Service Bulletin No. 452B

<i>MODEL</i> J4500	<i>TYPE</i> Field Change Program	<i>SECTION/GROUP</i> 12-Suspension	<i>DATE</i> June 9, 2017
<i>SUBJECT</i> FRONT SWAY BAR			
<i>CONDITIONS</i>

THIS BULLETIN SUPERCEDES SERVICE BULLETIN 452 IN ITS ENTIRETY.

Ref. MCI NHTSA Recall No.:17V-207

Figure 2. Sway bar installation.

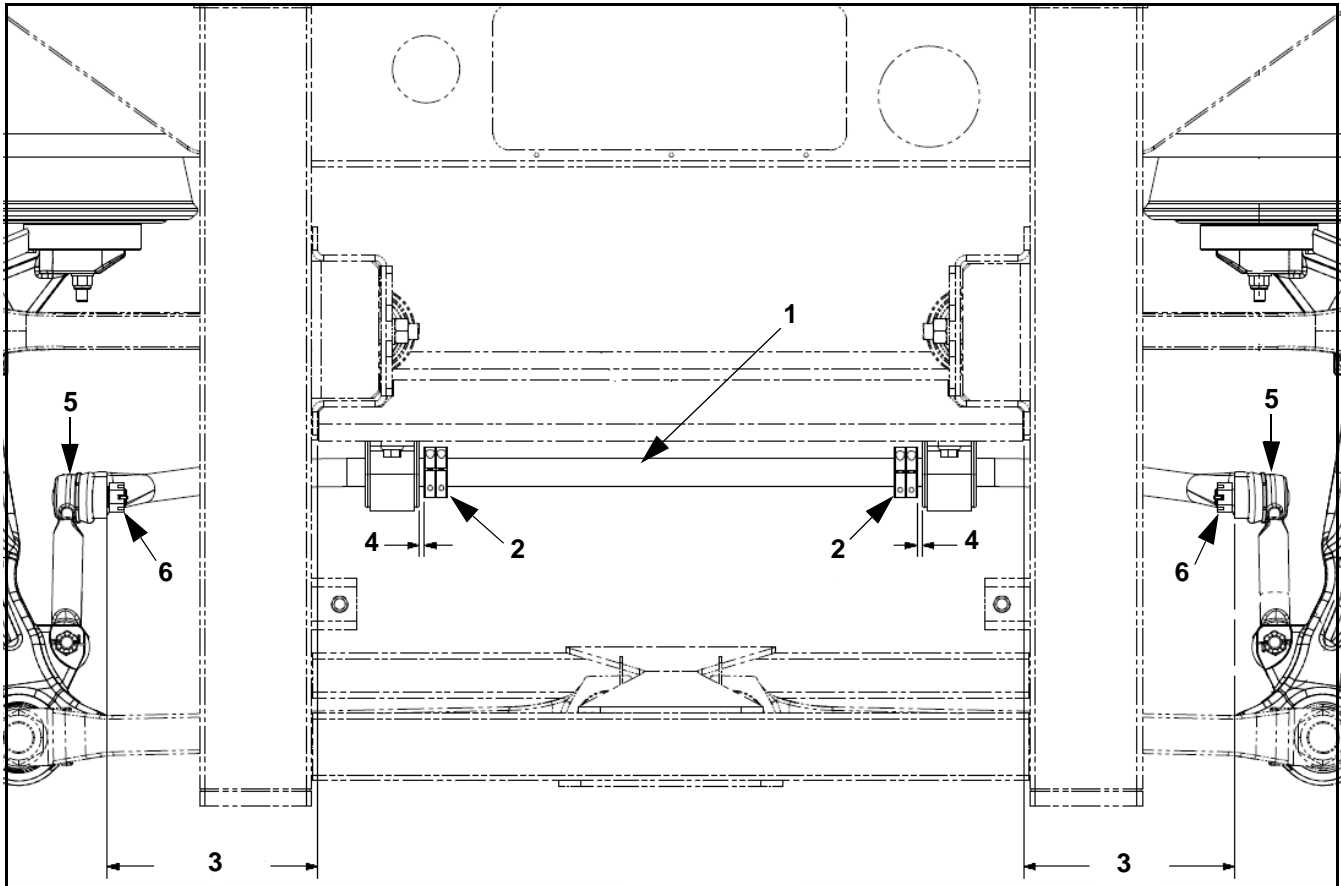
Motor Coach Industries ("MCI") has become aware that a defect which relates to motor vehicle safety exists on the front sway bar used on certain front axles. The potential exists whereas the front sway bar may crack at the bushing / clamp locations.

In the event that the sway bar cracks, it may detach from the coach affecting driving stability and increasing the risk of a crash causing injury and/or damage to property.

Fatigue failure of the sway bar under certain conditions.

Using a hammer, tap both ends of the sway bar to break the joint between the sway bar ends and the linkage (refer to Figure 2 / Items 1 and 5).

3. Remove and discard the existing front axle sway bar.
4. Install the new sway bar and service kit components as shown in Figures 2 and 3.

Item	Figure 2 Description
1	Sway bar
2	Collar. Torque collar allen bolts to 155-175 in-lbs.
3	Distance of 9.37 inches
4	Distance of 0.25 inch
5	Existing sway bars links. Ensure sway bars links are vertical and spaced equally from uprights.
6	Existing castle nut
